UNITED STATES PATENT AND TRADEMARK OFFICE

| APPLICATION NO. | FILING DATE | FIRST NAMED INVENTOR | ATTORNEY DOCKET NO. | CONFIRMATION NO. |
|-----------------|-------------|----------------------|---------------------|------------------|
| 10/700,390 | 11/03/2003 | Daniel Skorez | | 5807 |

Office Action Summary

DETAILED ACTION

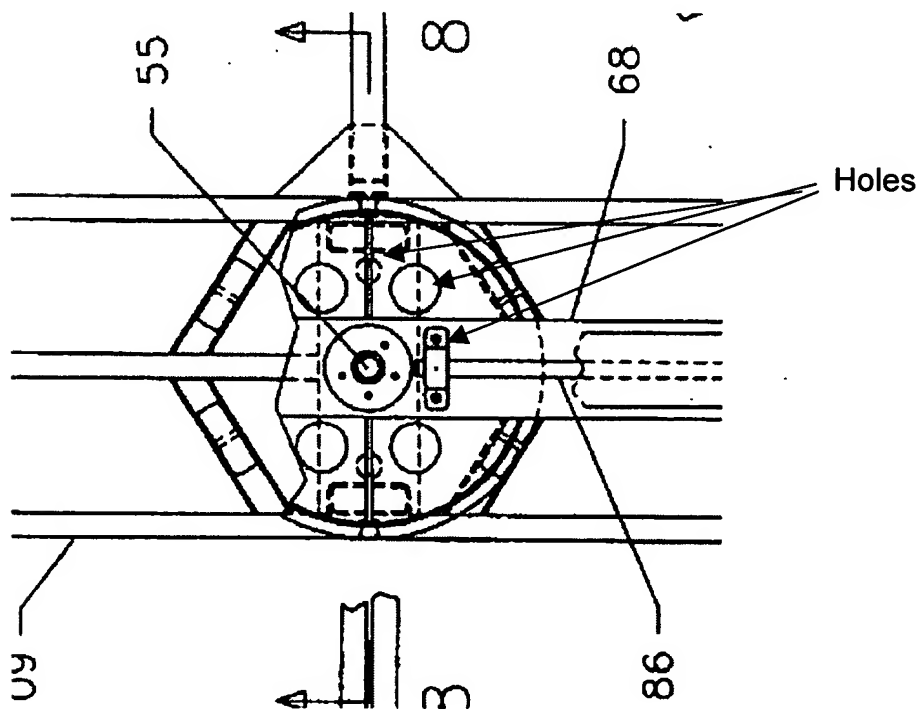
6. Claims 1-8 are rejected under 35 U.S.C. 102(b) as being anticipated by Andol (US 6,086,082).
7. With respect to claim 1, referring to FIGS. 1-15 Andol '082 discloses a system 10 comprising a bearing plate 64,82, rear portion 28, truck or trailer 10, positioning means 112, 114, rotation stop means 140, 150, 76, 78, mounting frame 40, first frame section

109, second frame section 109, lateral beams 36, first frame rail 18, second frame rail 18, bracket 64, turntable or thrust bearing 66, 72, first wheel assembly, 60, second wheel assembly 60, first rotation lock 140, second rotation lock 140, bumper 30,32, first bumper tab 115, and second bumper tab 115, first travel lock, col. 7, lines 9-11, and second travel lock, col. 7, lines 9-11. It is noted that Andol '082 anticipates that two travel locks may be employed. Col. 7, lines 14-15.

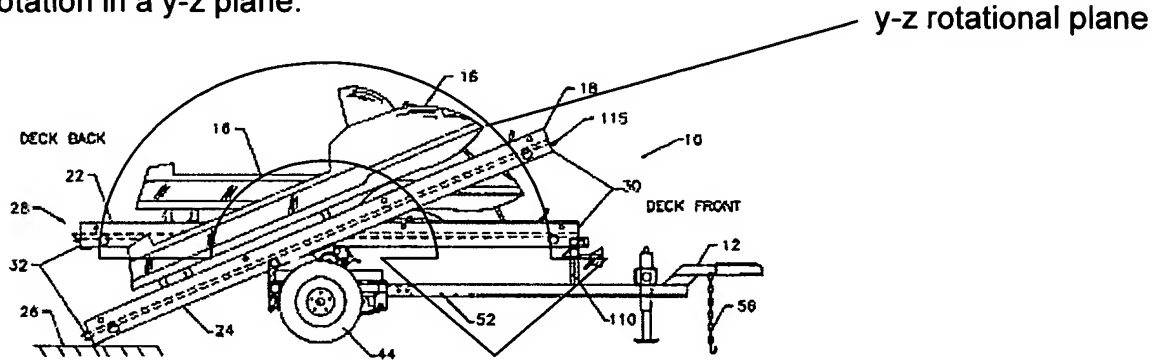
9. With respect to claim 3, referring to FIG. 6 Andol '082 discloses a bearing plate 64,82 having holes as defined by those apertures as shown below.

10. With respect to claim 4, referring to FIG. 6 Andol '082 discloses first travel stop 150, and second travel stop 150. It is noted that Andol '082 is not limited to merely

allowing travel of the mounting plate to 180 degrees in an x-y plane but also allows rotation in a y-z plane.

FIG. 7

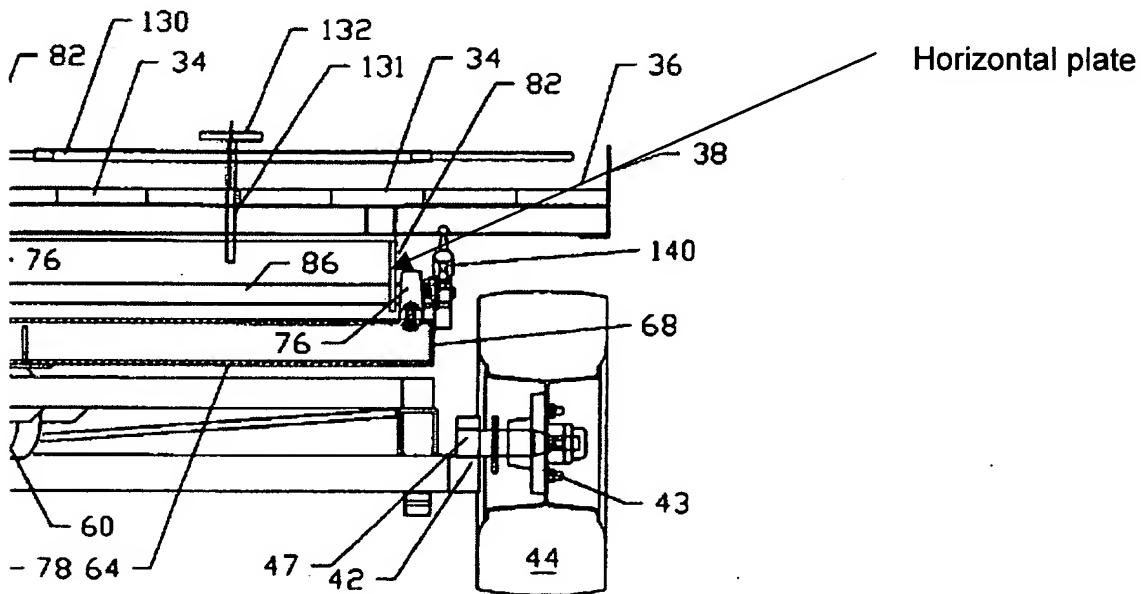
12. With respect to claim 6, referring to FIGS. 6-8 Andol '082 discloses first rotation lock 150, mounting bracket 76, horizontal plate 82 see below, hole, spring loaded pin 140, 142, 144, second rotation lock 150, mounting bracket 76, horizontal plate 82, hole, spring loaded pin 140, 142, 144.
